Re: Response to Comments by County of Riverside Planning Department
Savira Solar
Desert Center, Riverside County, California
Terracon Project No. CB255153

Response to County Comments

Savira Solar | Desert Center, Riverside County, California
June 16, 2026 | Terracon Project No. CB255153

Geologic Index Map

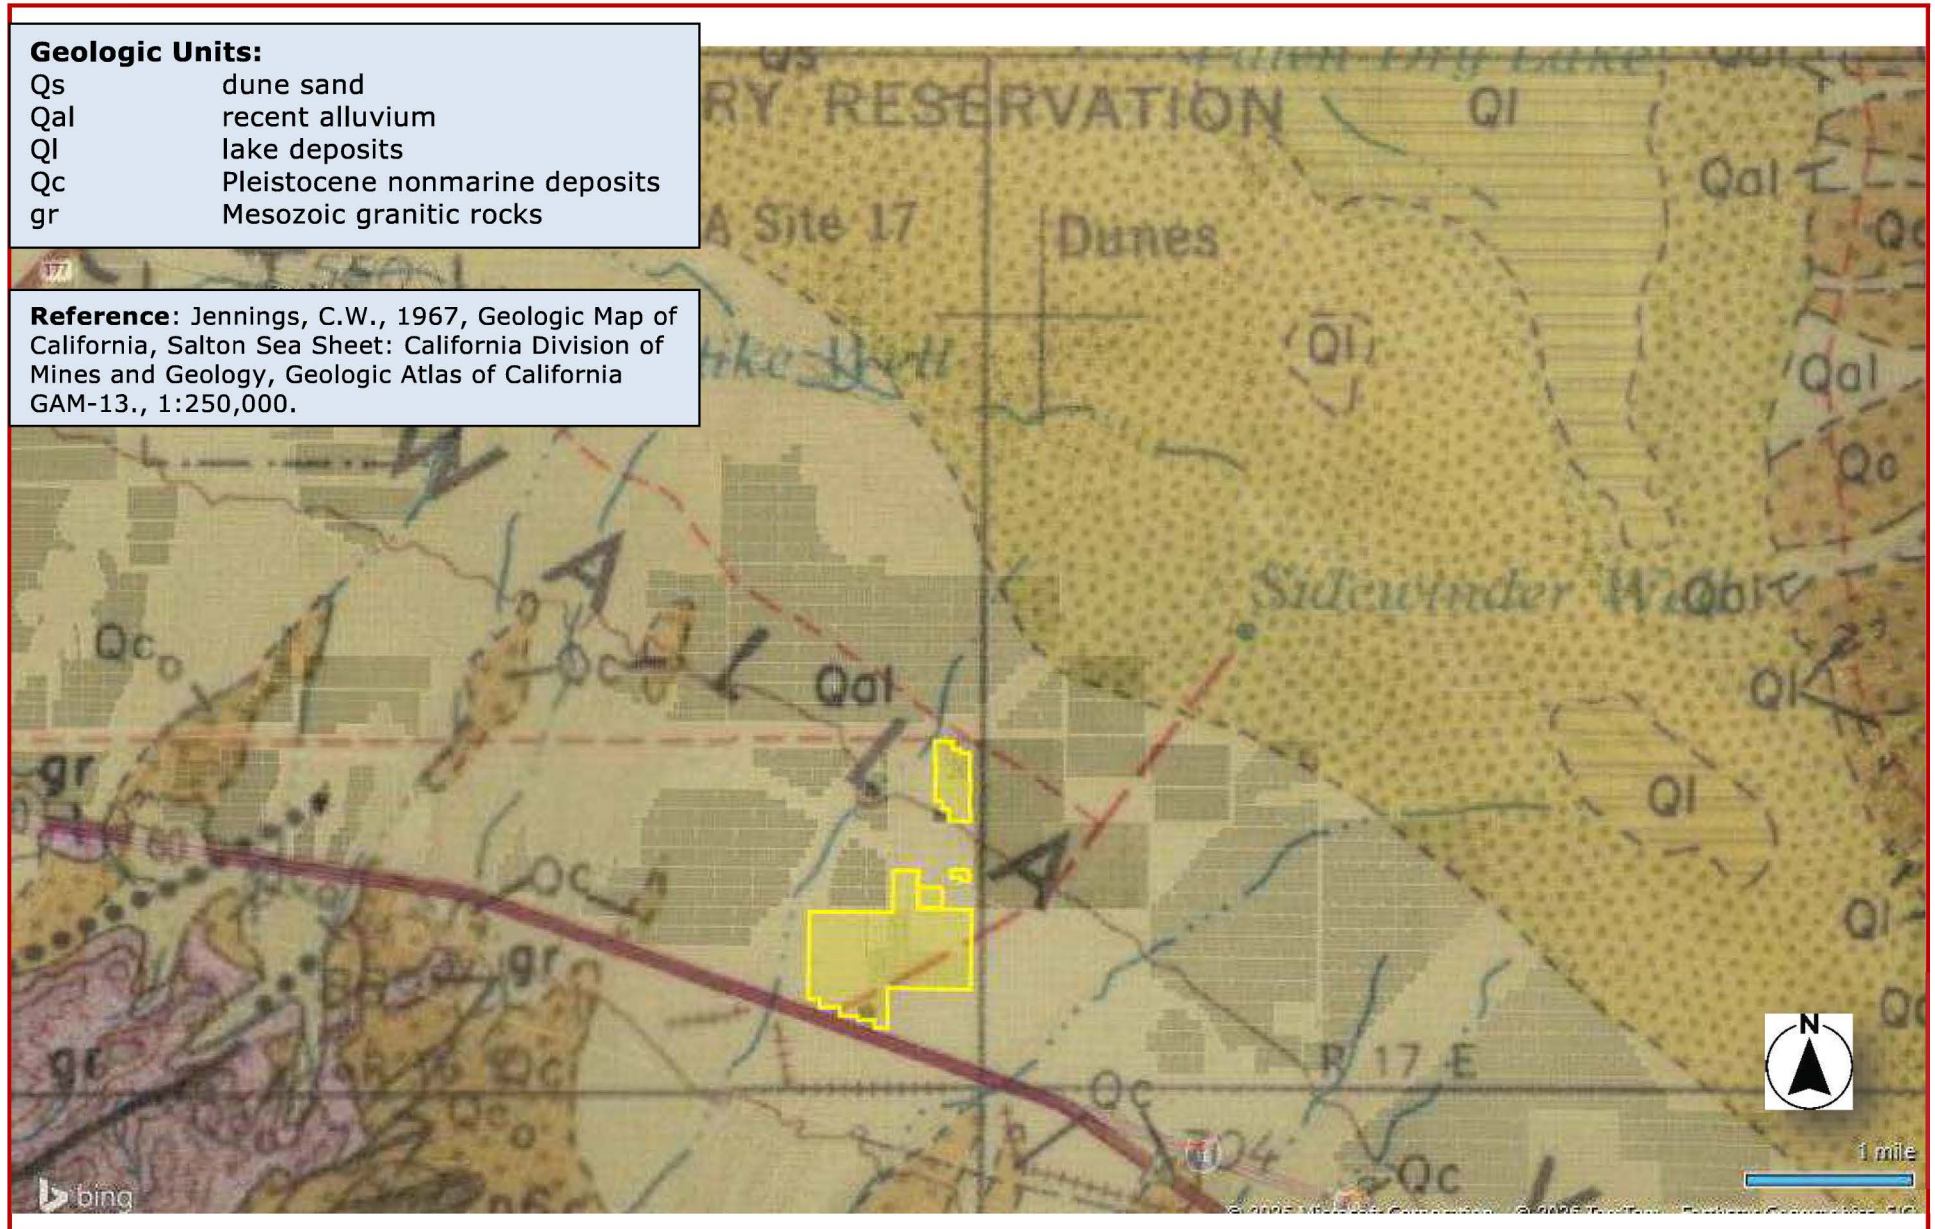
County Comment 2: *"Please provide regional and local geology maps showing the site relative to geological units and nearest active faults."*

Response 2: . A **Geologic Index Map** depicting the local geologic units and others in the Chuckwalla Valley is attached. A **Regional Fault Map** is attached.

Lidar Map

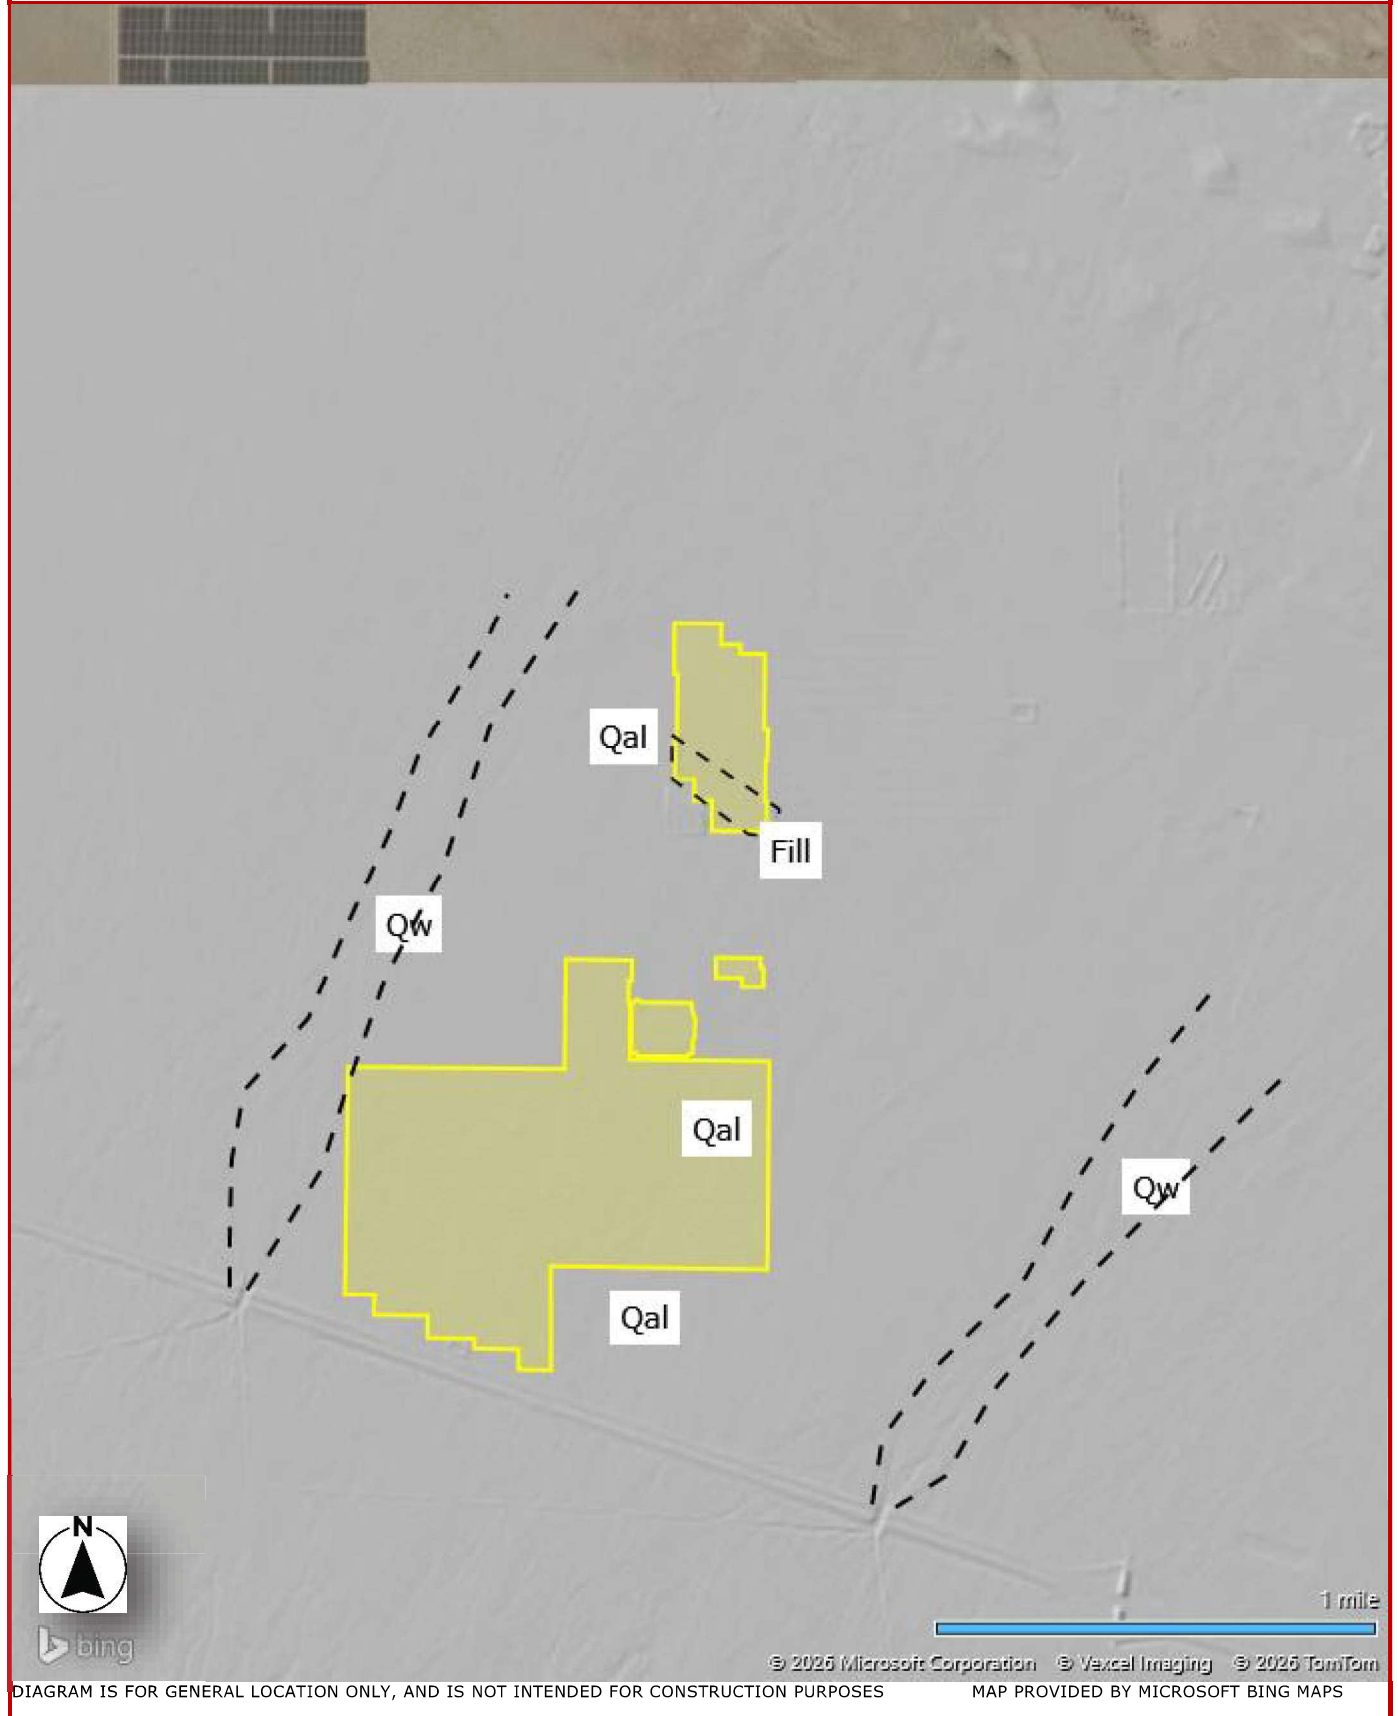
County Comment 3: *"Please address the potential of active faults at the site. Provide positive lines of evidence, based on site-specific geological observations, to support the opinion regarding active faulting on the subject site (perform geological mapping of the site, and evaluate presence or absence of lineaments, scarps, other features shown on referenced historic aerial photographs and maps, etc.). Not being in a published fault zone or not having a published fault trace, on or projecting toward the site, does not*

preclude the existence of active faults at the site (California Geological Survey, Special Publication 42, 2018) and the requirement for actual site geological mapping by a California Certified Engineering Geologist. Site-specific geological information must be provided to support the opinion."

Our investigation for this response did not reveal any evidence for disruption of this slope, such as changes in slope (inflections) or scarps. Lidar imagery available from the USGS (<https://apps.nationalmap.gov/3depdem/>) for the site also confirms a uniformly sloping surface with no evidence for faulting. See attached **Lidar Map**.

Response 3: This response has been prepared and reviewed by an Engineering Geologist. Review of published geologic mapping, LiDAR imagery and historic aerials (dating back to 1953) show a uniform northeasterly-sloping ground surface in the site area, with no evidence for slope inflections, lineaments, scarps, springs or other potential manifestations of faulting.

ASCE Hazards Report

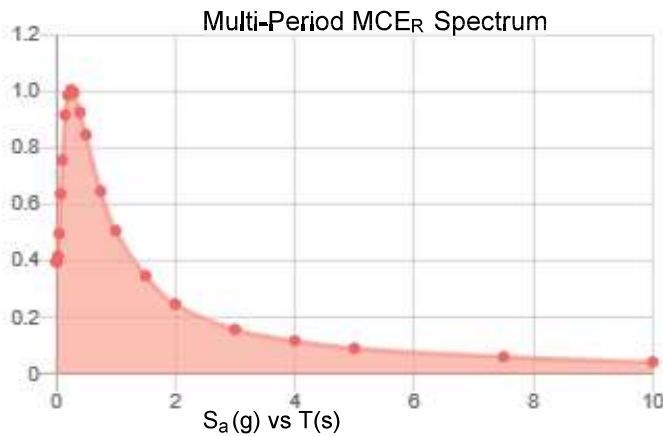
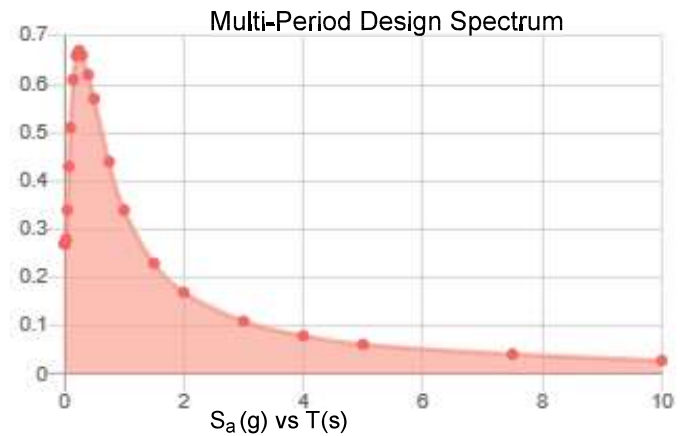
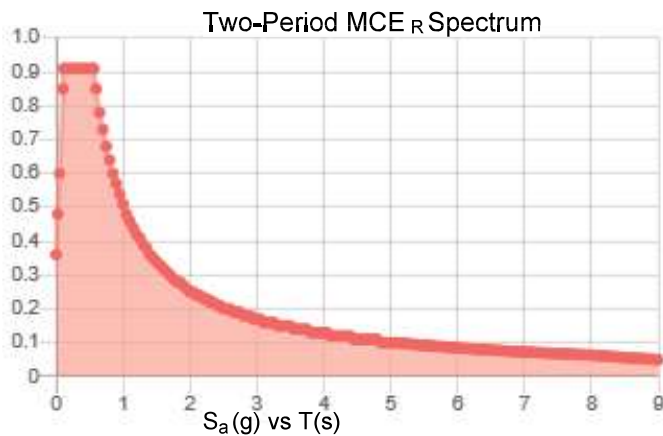
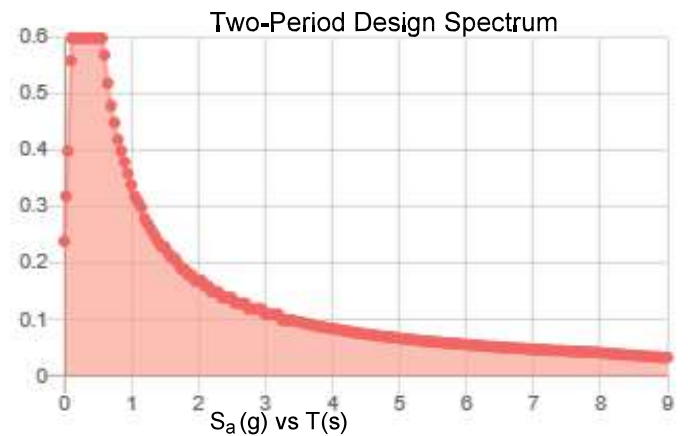
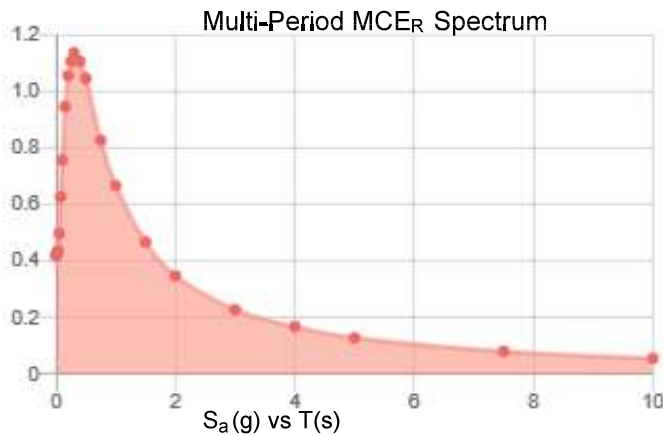
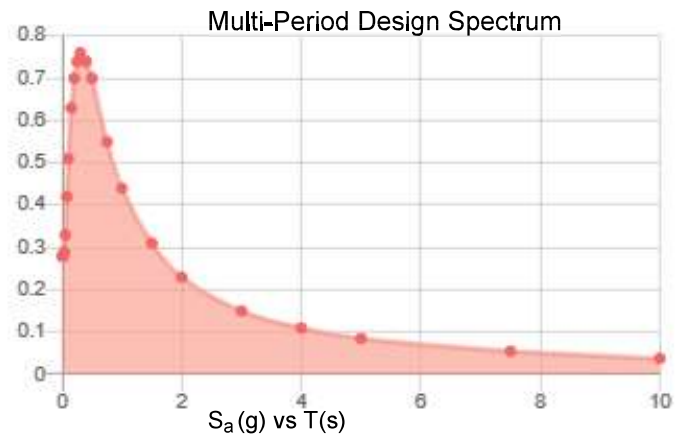
County Comment 5: *"Page 8 of the report states that the governing seismic design parameters are based in part on results from previous versions of this report. Please provide the previous analysis and results for determining the three site class scenarios in the current report. Please provide the ASCE Hazard Tool output results."*

Response 5: Page 8 of the report states "Previous versions of this report presented results considering this approach". The seismic parameters from the previous versions of the report are the same as the ones included in the final report. Our analysis for determining the three site class scenarios as well as the ASCE Hazard Tool and Unified Hazard Tool output results have been included as attachments to this letter.

LIQUEFACTION ANALYSIS

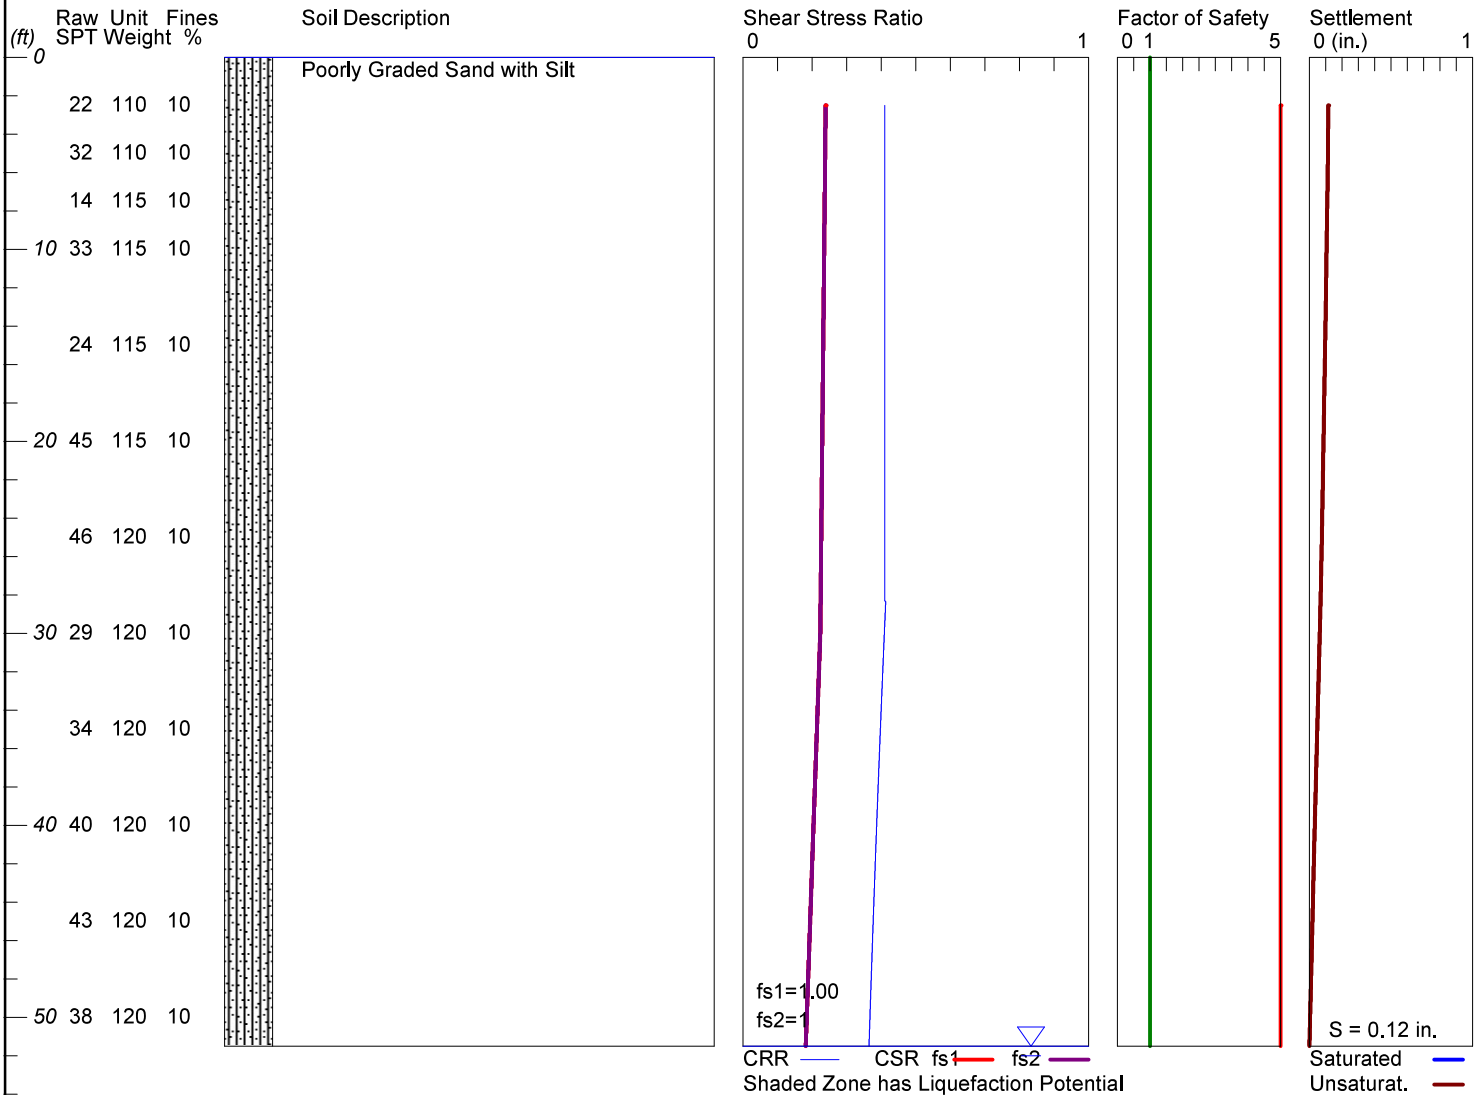
City Comment 4: *"Please provide total and differential settlement values (not estimates) for static and dynamic conditions based on site-specific data and analysis"*

The analysis results show that seismically induced settlement of dry/unsaturated sands at the site is estimated to be on the order of 0.12 inch. The maximum differential seismic settlement could be on the order of one-half of the total seismic settlement over a distance of 50 feet. This anticipated seismic settlement combined with static settlement of 1 inch for the recommended foundation bearing pressures included in the original geotechnical report, are within generally accepted tolerances for shallow spread footing foundations planned for the improvements and additional recommendations are not required at this time.

Response 4: The requested total and differential settlement values have been provided in this response and the settlement analysis has been included as an attachment to this letter. The total settlement value was calculated to be approximately 0.12 inch and differential settlement is considered to be half of the total settlement.
